**ICC 500-2020 edition
Public Input Agenda with
Committee Votes and Public Comments
based on input received
on 2014 edition of the
ICC 500 Standard**

**For February, 2020
2nd Meeting – Teleconference**

2014 ICC 500-Standard Revision Proposals – Public Comments

FIGURE 304.2(2)
DESIGN WIND SPEEDS, ψV_H , FOR HURRICANES

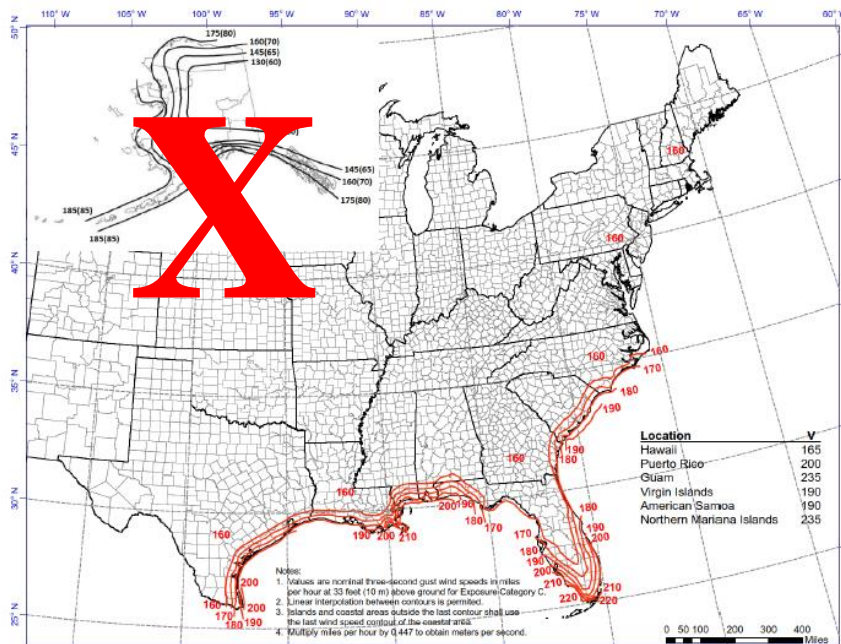
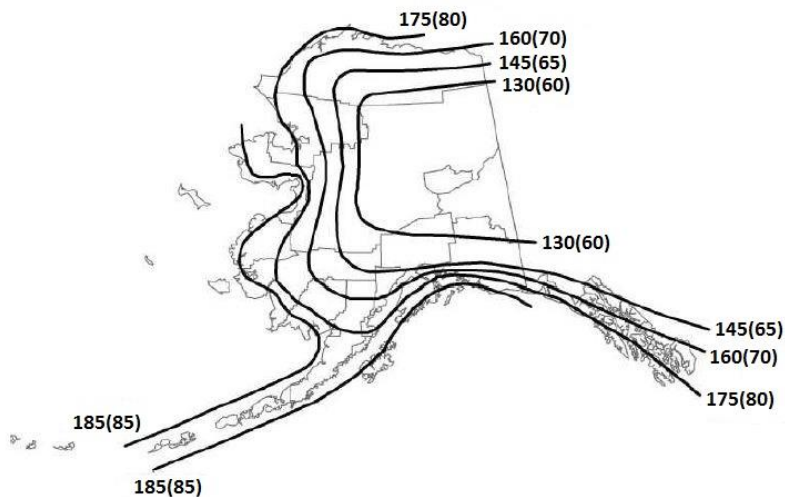
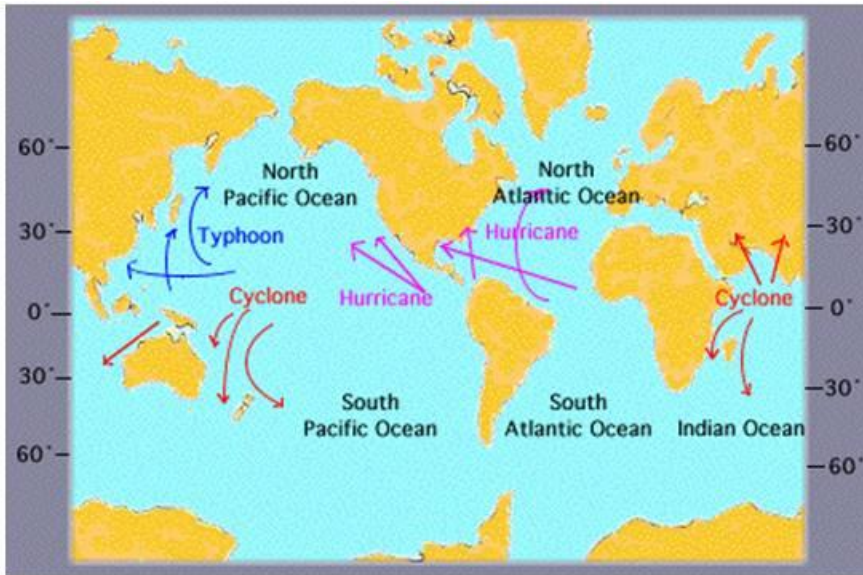
Note: Remove Alaska from current figure 304.2(2)

304.2 Design wind speed. For *tornado shelters*, the *design wind speed*, ψV_T , shall be in accordance with Figure 304.2(1). For *hurricane shelters*, the *design wind speed*, ψV_H , shall be in accordance with Figure 304.2(2). For storm shelters in Alaska the design wind speed, V_H , shall be in accordance with Figure 304.2(3).

FIGURE 804.9.5(3)
ROLLING DOOR ASSEMBLIES

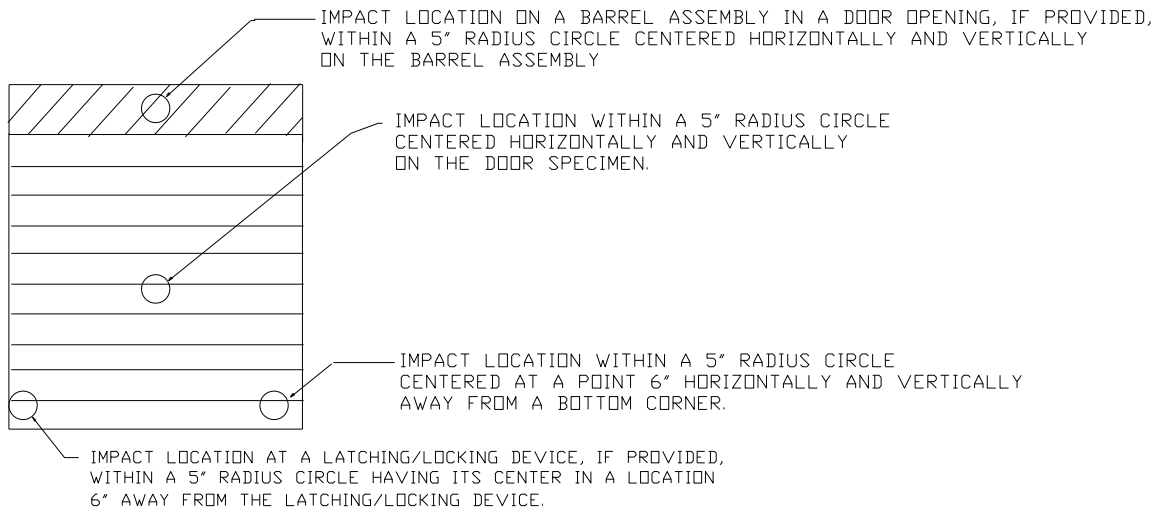
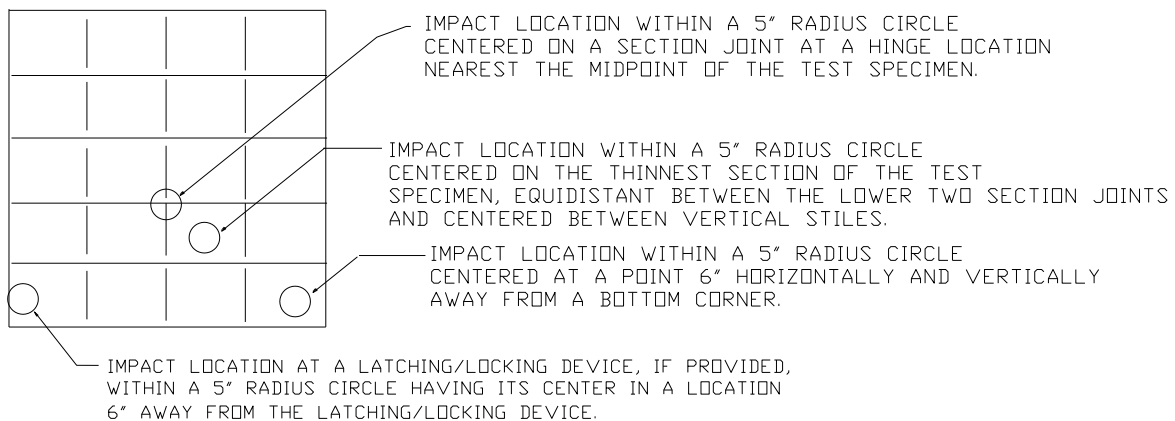
Reason: Clarify application of door impact provisions with respect to testing of rolling and sectional doors

**FIGURE 804.9.7.2
DOORS SUBJECT TO REBOUND IMPACT**

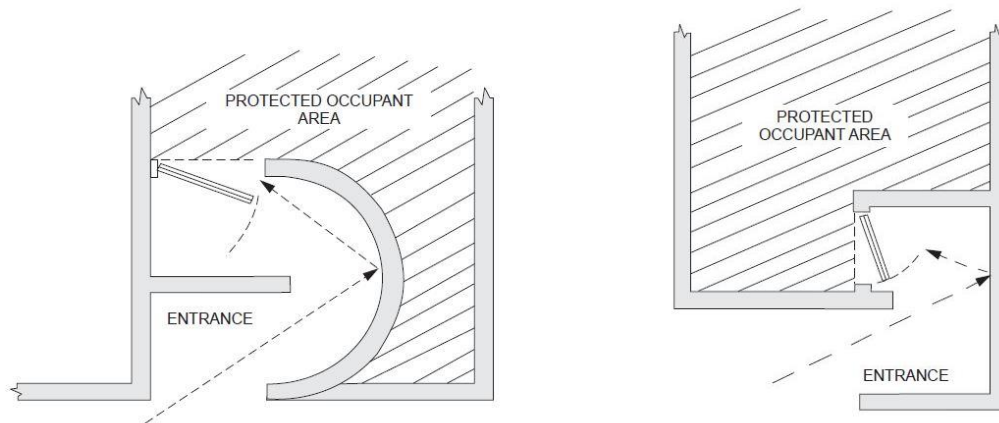
Reason: The way figures are referenced is not consistent and does not make the figure part of the requirement. Using “as detailed in” or “as shown in” would be consistent with the figure references of impact location in 804.9. In Items 1, 2 and 3 of Section 804.9.7, “Examples of this type of system are shown in Figure...” is not needed. As written it is editorials information, not a requirement; and the figures are referenced in each of the referenced sections.

804.9.7.2 Door subject to rebound impact. Where the alcove or baffled entry system prevents a first impact of the design missile on the door but the door is subject to a rebounded impact of the design missile after it has impacted one surface meeting the requirements of Section 306.2 possible (~~see [as detailed in](#) Figure 804.9.7.2~~), then a door assembly shall meet the wind load requirements of Section 304 and the debris impact requirements of Section 305 except that the missile shall be, at a minimum, a 9-pound sawn lumber 2 by 4 traveling at 50 feet per second (15.2 m/s). Entry systems having doors that are protected from the initial and first rebounded impacts of debris shall comply with the requirements of Section 804.9.7.1.
